SF718 A

Subject: Transmission Oil Cooler Line Clearance

SF718 – Modification of the Right-Hand Baffle

Fig. 1, Cut-Out Adjustment Dimensions

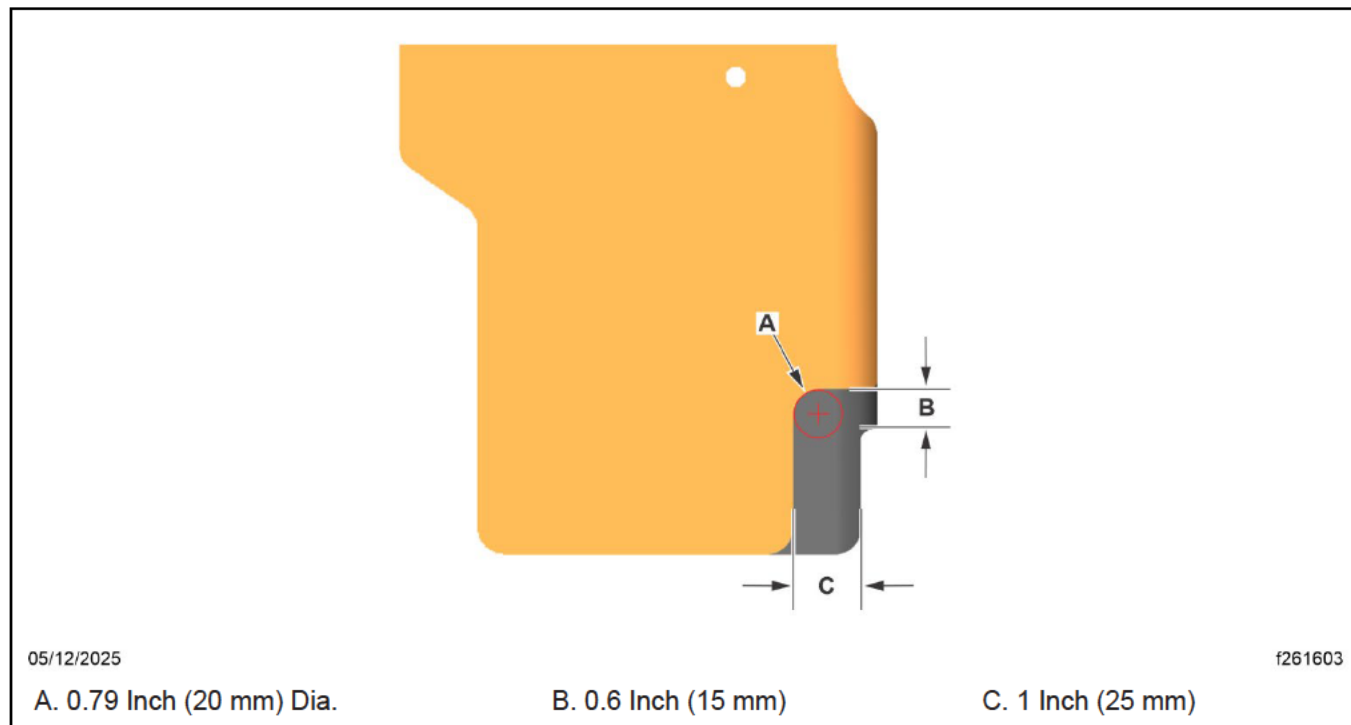
6. Mark the new cut-out shape for the transmission cooler plumbing, per the dimensions detailed in [Fig. 1](#).

7. Modify the recirculation baffle by drilling a hole at the intersection and cutting in from the edges.
8. Inspect the cooler lines for evidence of wear in the section where the baffle is close to or contacting the line.
Does the line show evidence of wall thickness thinning, or deep grooves?
YES → Replace the damaged line; continue with step 8.
NO → Go to step 19.
